RE: C. of O. for # 75A, 75B, 77 Maggie Lane (341-A-022)

Re: Setbacks, Lot 12, Maggie Lane Subdivision

BUILDING PERMIT REPORT

RE: Response to your comments on lot # 12 Maggie Lane

Figure No.
2

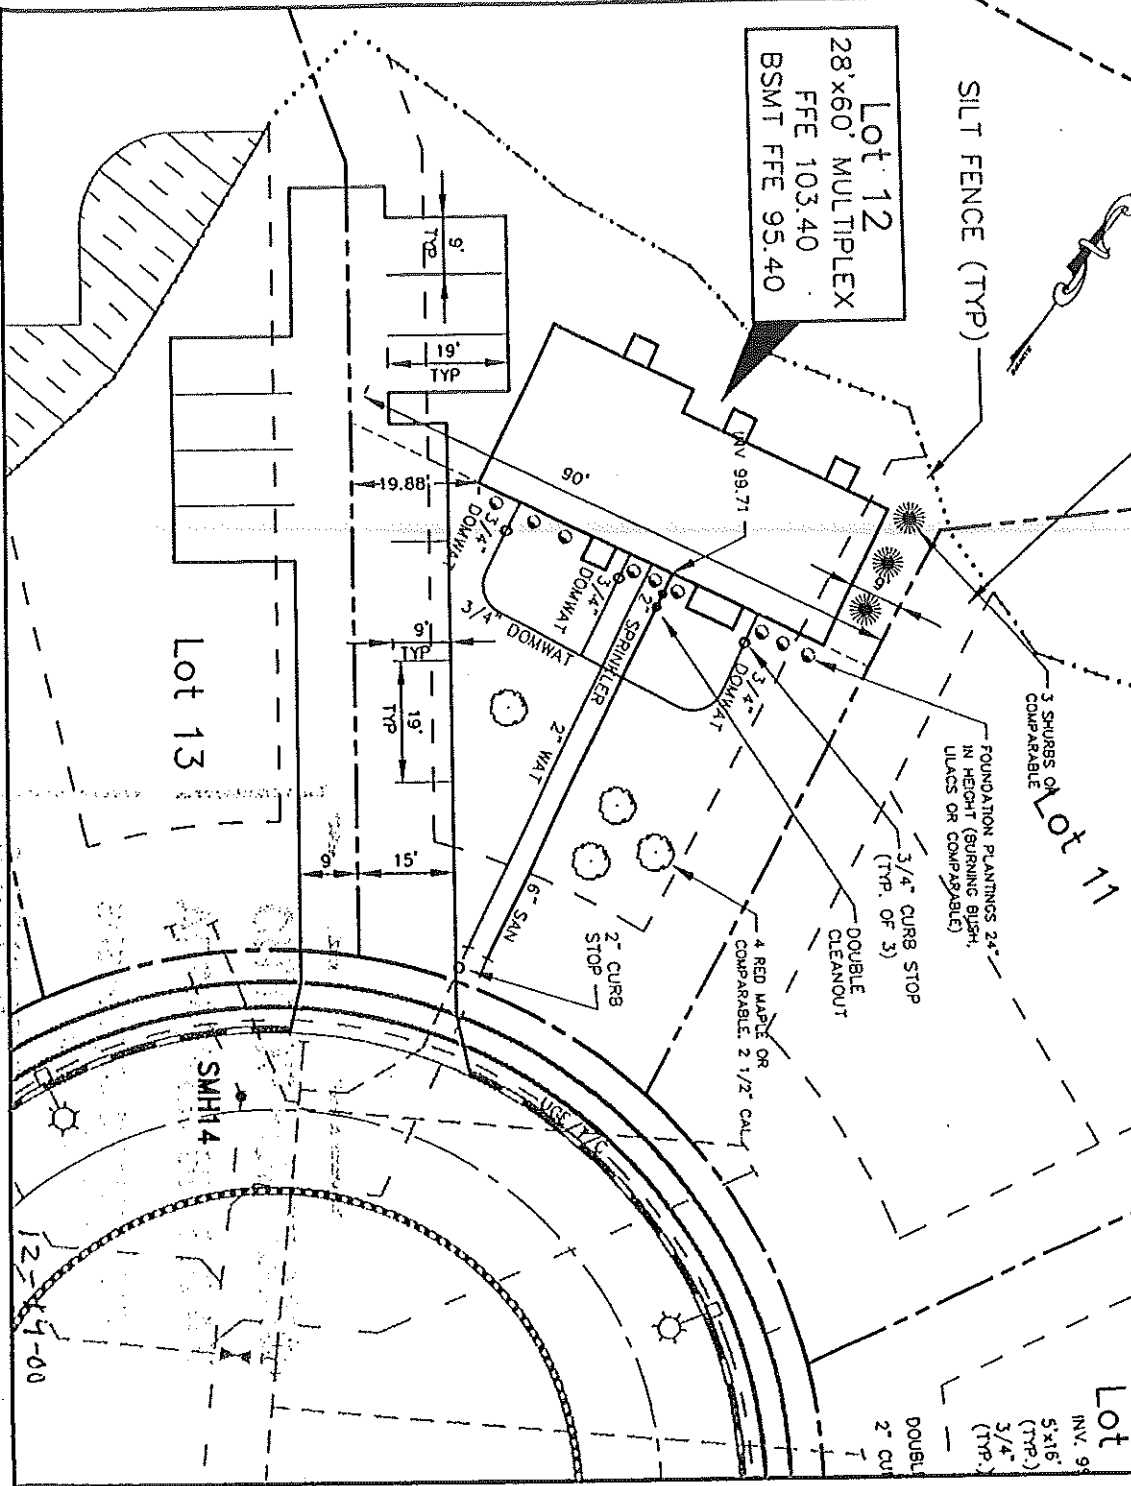
EACH UNIT ON LOT 12 MAY HAVE A FUTURE REAR DECK WITH ~~OPTIONAL STEPS TO THE GROUND~~ **NOT ALLOWED** APPROXIMATE CONTRACTOR SHALL BE RESPONSIBLE FOR 4'x4' DECK WITH STAIRS FROM BASEMENT TO GROUND

Figure No.
3

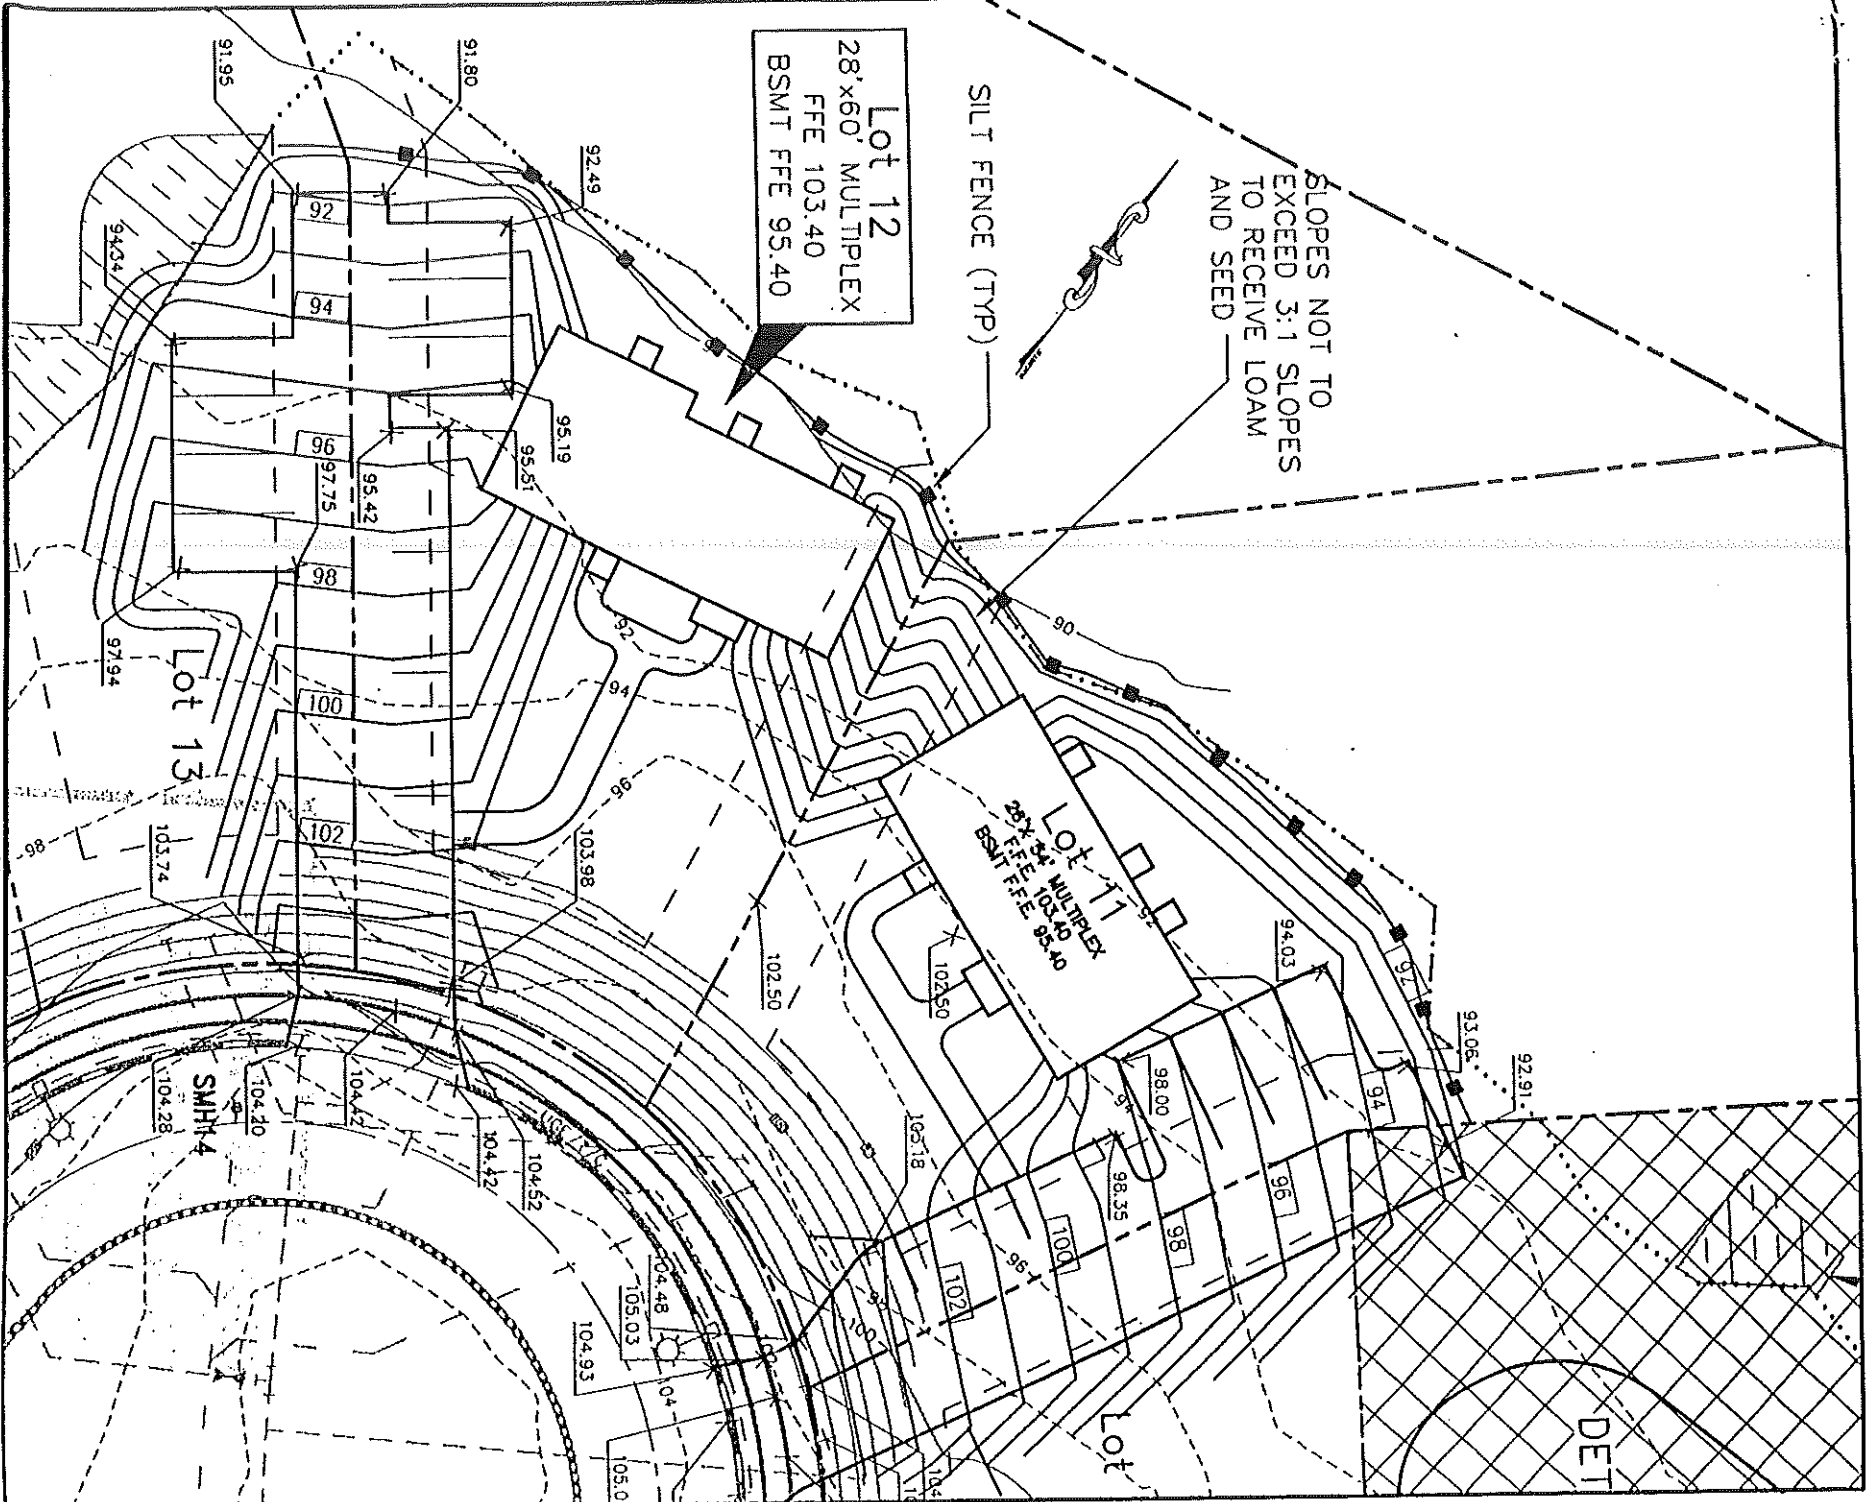
1. SITE PLAN SHOULD SHOW THE DECK FOOTPRINTS AND BRICK STAIRWAY. THERE IS A SIGNIFICANT 5' FOOT DROP FROM THE FLOOR TO THE GROUND. STAIRS ARE A CODE REQUIREMENT.

2. SUBMIT SPECIFIC SLOPE STABILIZATION MEASURES ON THE PLAN. ONE OPTION IS TO MAKE IT LESS STEEP. WE WILL NOT ACCEPT MORE THAN A 3 TO 1 SLOPE.
3. INDICATE INSTALLATION OF A MET FENCE UPBAND FROM THE WESTLAND PAVION TO CONSTRUCTION.

1. The decks and stairs have been added to the site plan.
2. GORTL-Palmer & Steve Busby from DeLuca - Hoffman, both agree that RipRap is an acceptable slope stabilization measure. There is no way to get a 3 to 1 slope with a 12' drop over 24'. Both the Buyers for lots 11 & 12 do not want retaining walls between buildings for liability and maintenance reasons. If we bring the slopes out past the front of the Buildings the sides would have to become a daylight basement, this would effect our building envelope, grading and final appearance that the purchasers are looking for. We have been patient with this process but we feel it is putting extra burden and is unreasonable to force the purchasers into something they do not want.

3. The silt fence is in place, but we will add it to the site plan.
4. The set back issues have been addressed with Marge at my meeting with her last week. There is a 12' setback because less than 1/2 of the building is daylight walls, if more than 1/2 was daylight then it would have been 2.5 stories.
